Bradley Heights Apartments

A 236-Unit Apartment Development Puyallup, Washington

Bradley Heights SS LLC

BUILDING B
1/8" = 1'-0"
1st LEVEL PLAN
3/4 SPLIT LEVEL, 14-UNIT BUILDING

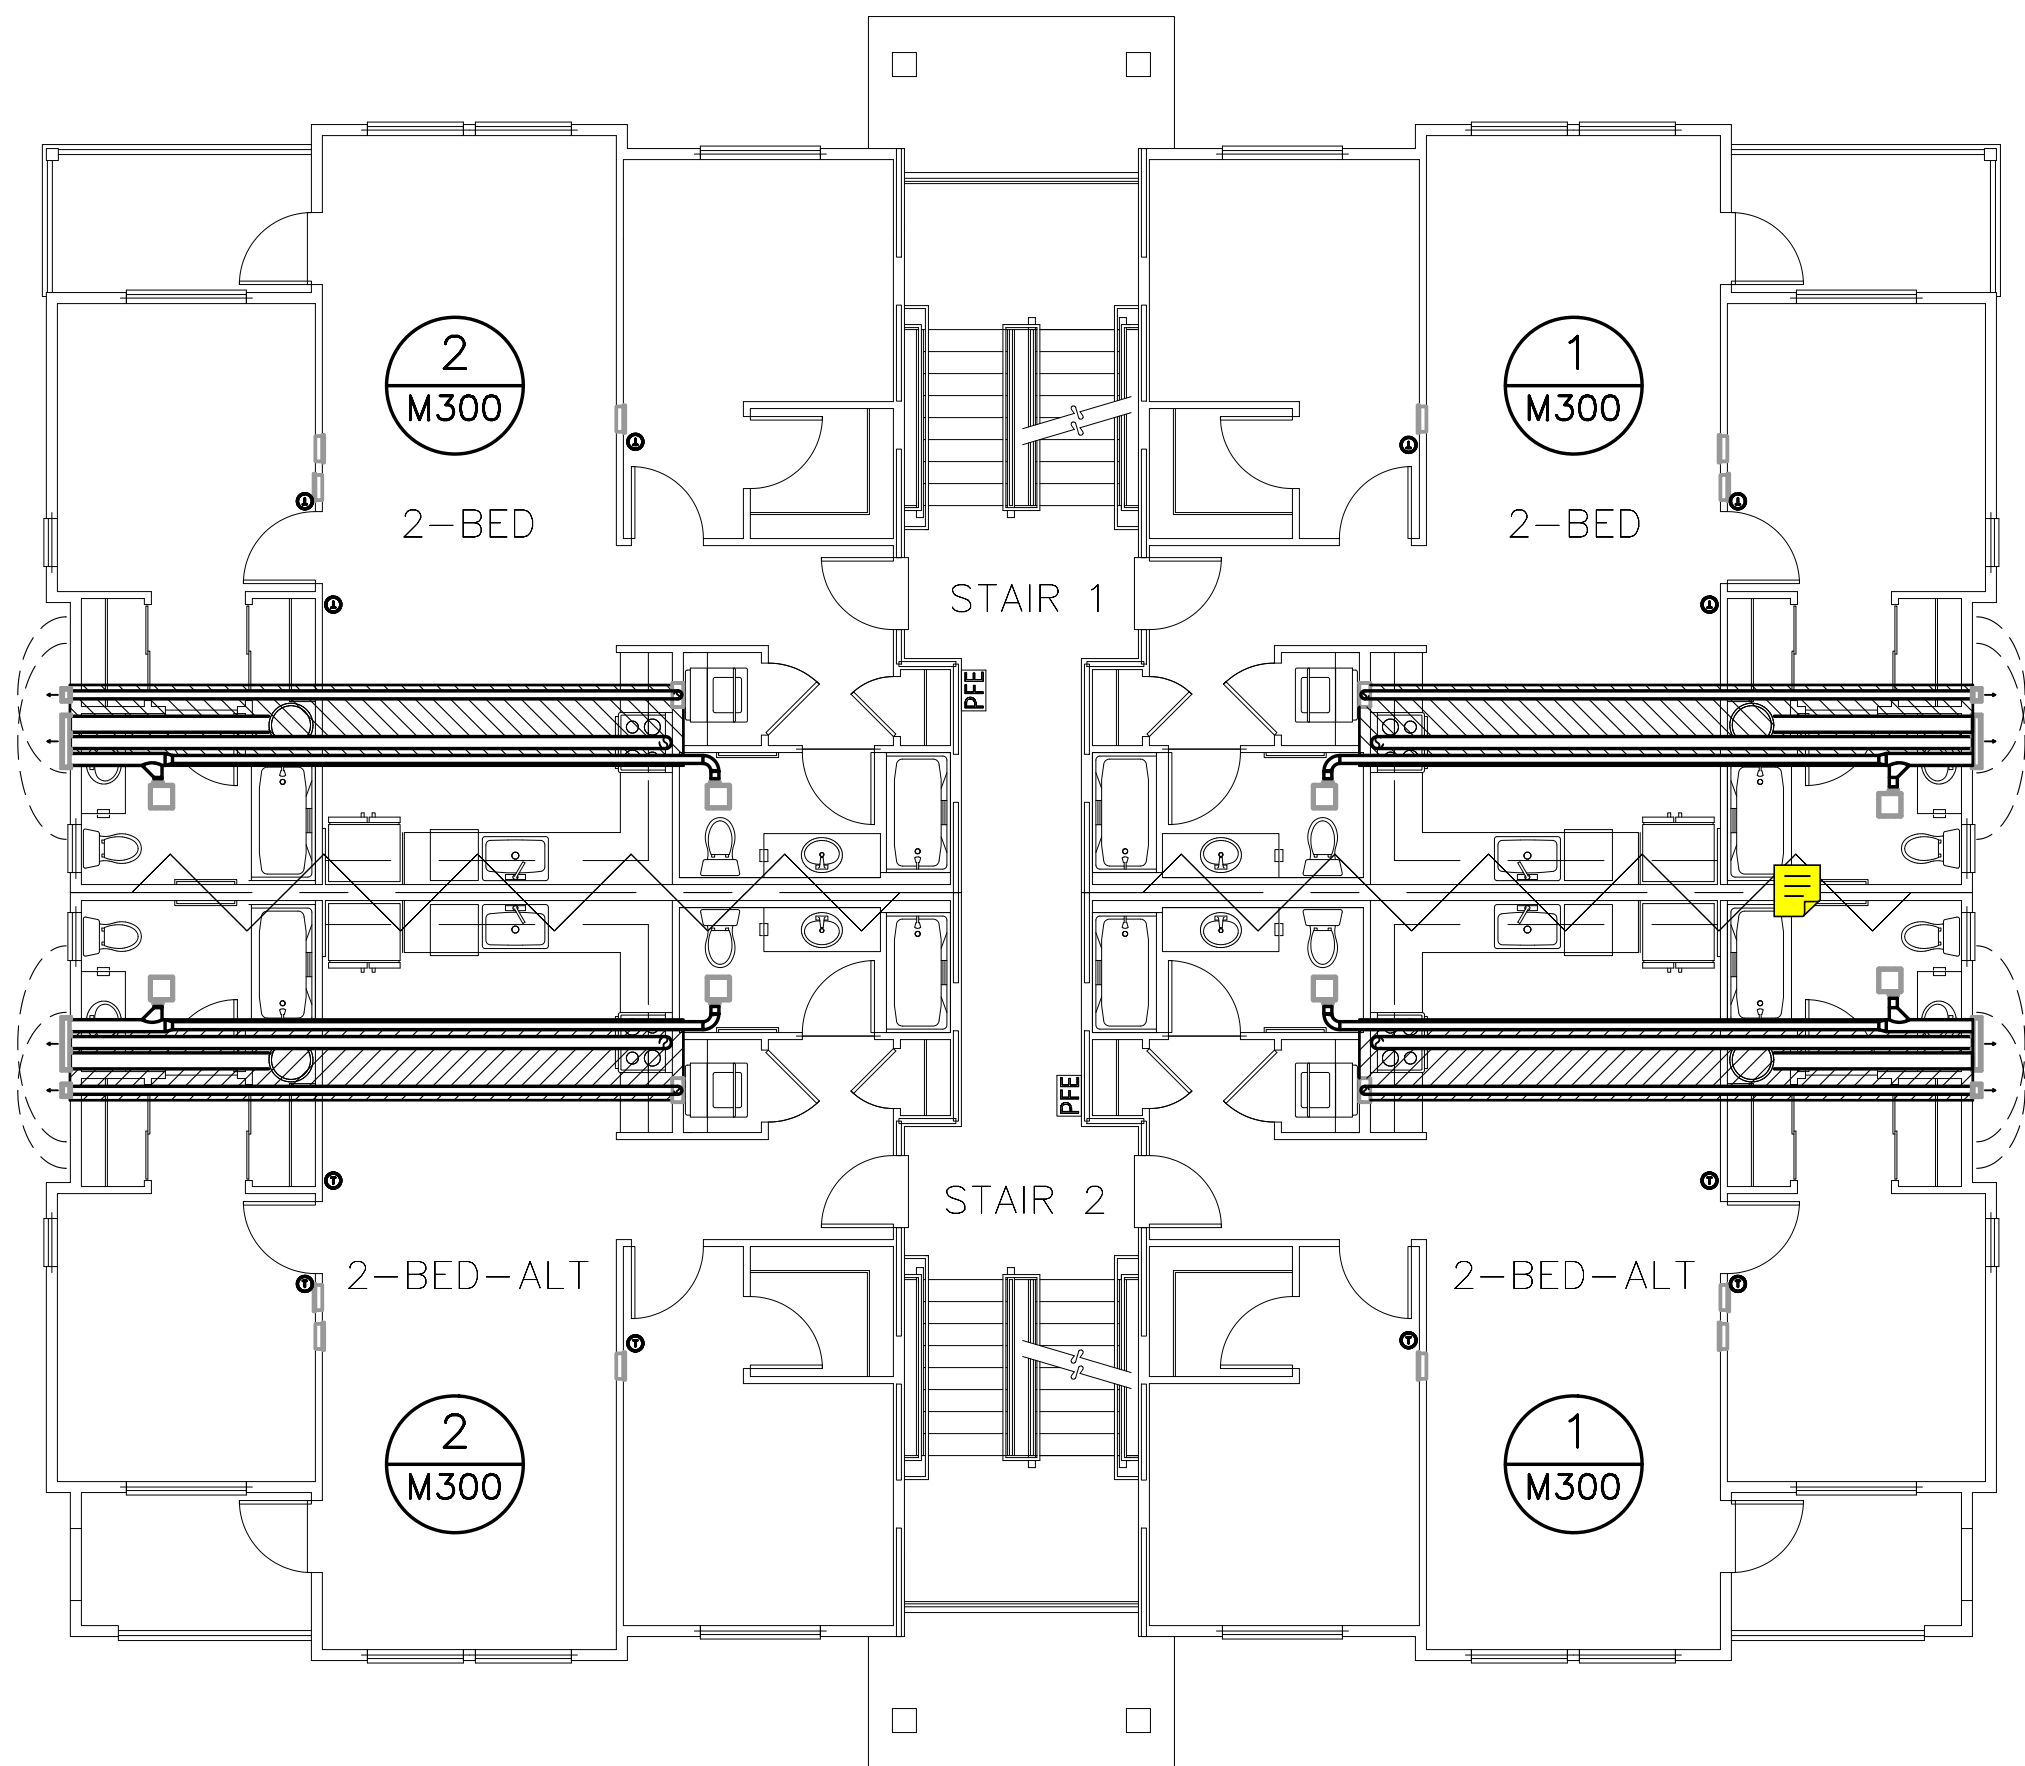
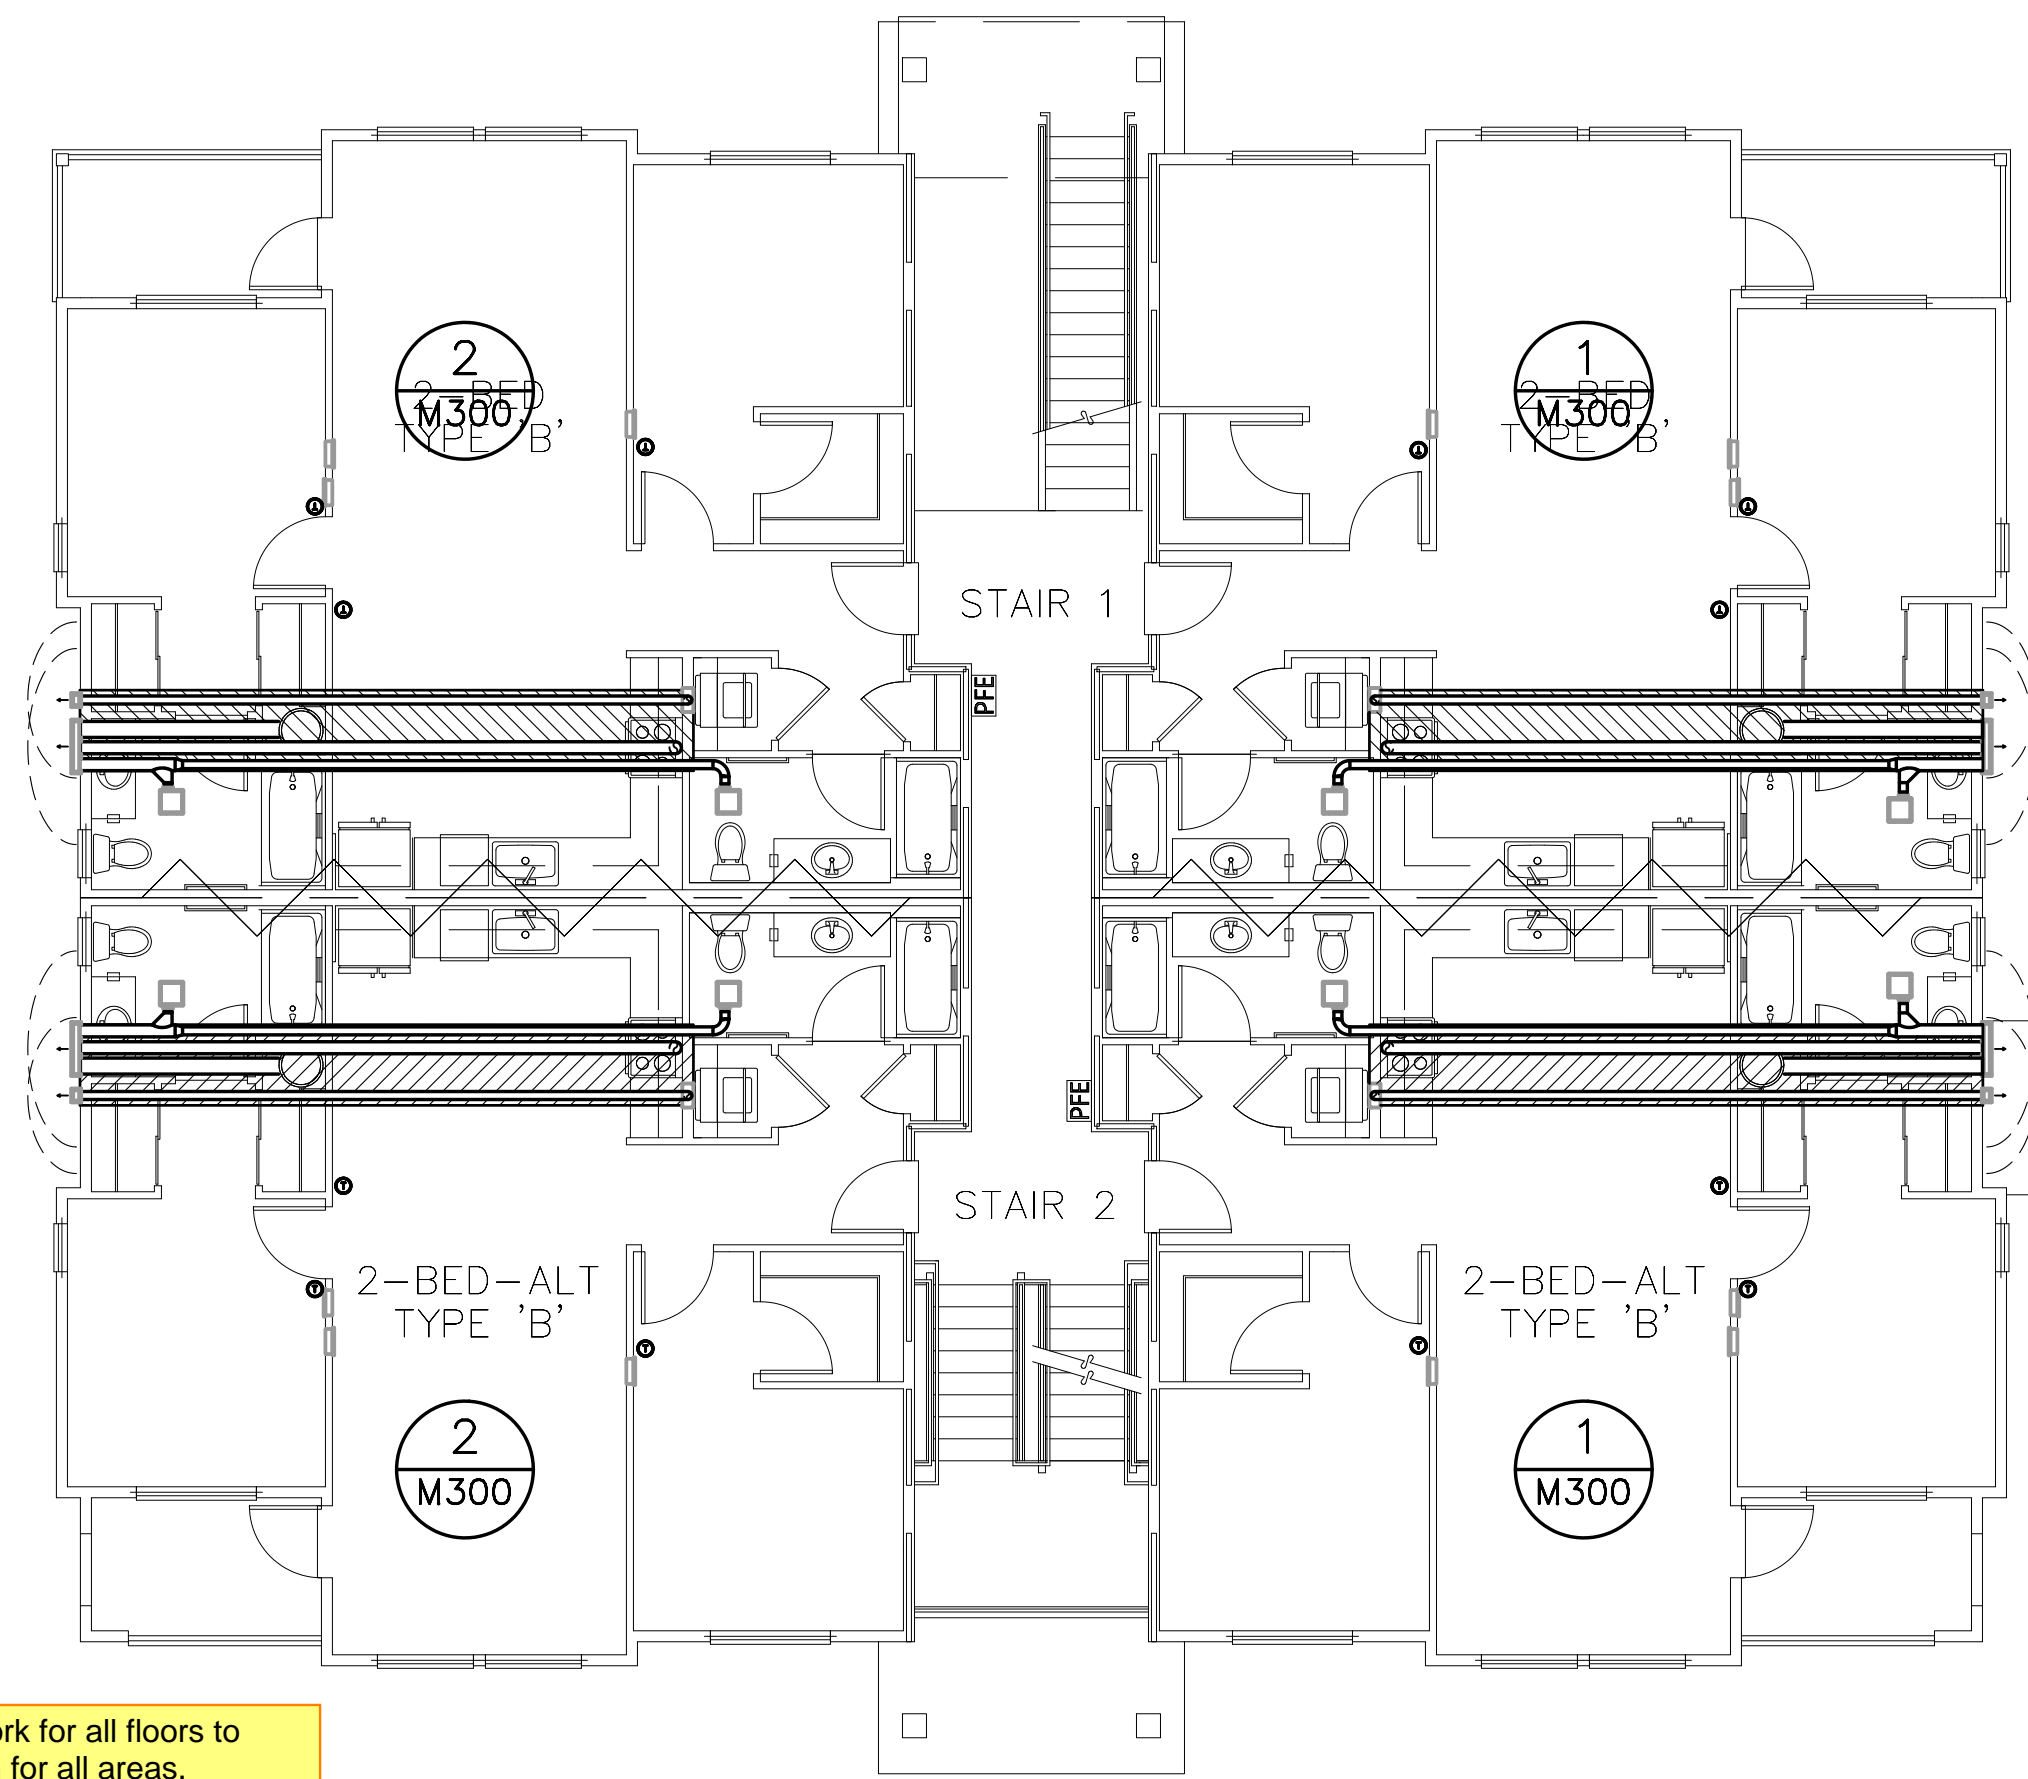
Provide lengths to all duct work for all floors to identify maximum duct length for all areas.
Page M2.0
